MFN 06-216

Subject: **Response to Portion of NRC Request for Additional Information
Letter No. 34 Related to ESBWR Design Certification Application –
Auxiliary Systems – RAI Numbers 9.3-3 through 9.3-10 and 9.3-12
through 9.3-23**

Standby Liquid Control System

RAI Numbers 9.3-3 through 9.3-10 and 9.3-12 through 9.3-23

Figure 9.3-3-1 Standby Liquid Control System Simplified Process Diagram

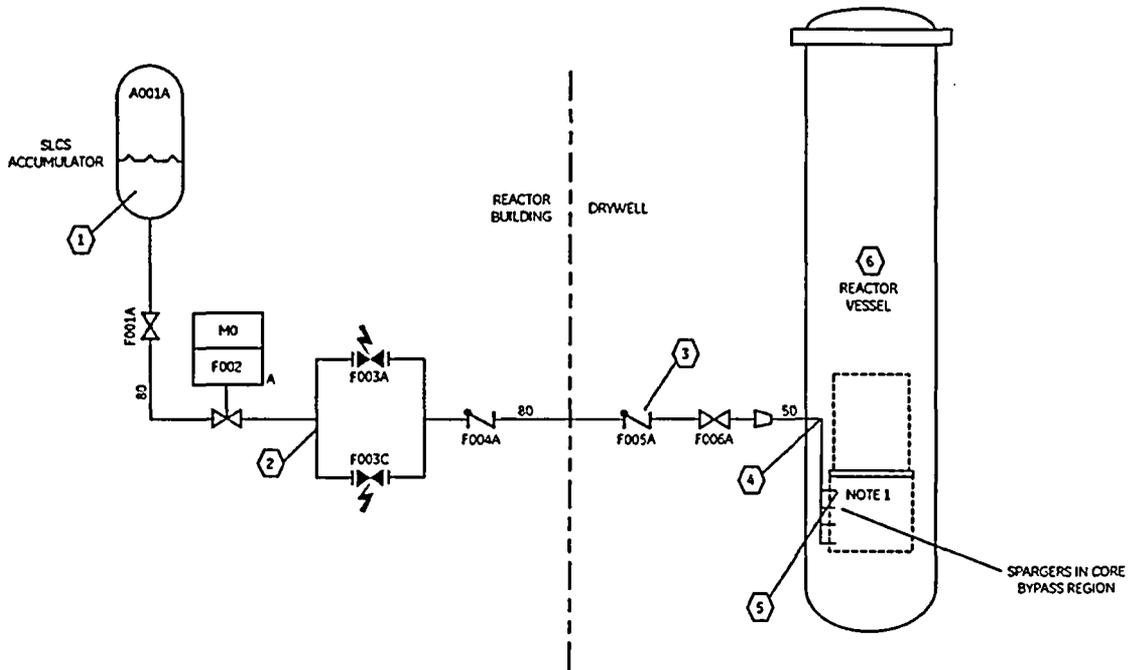
NRC RAI 9.3-3

Provide a process diagram showing the SLCS operating parameters: pressure, temperature and flow rates.

GE Response:

A simplified SLCS process diagram is provided in the attached figure. DCD Tier 2 Subsection 9.3.5 will be revised in the next update to incorporate this figure.
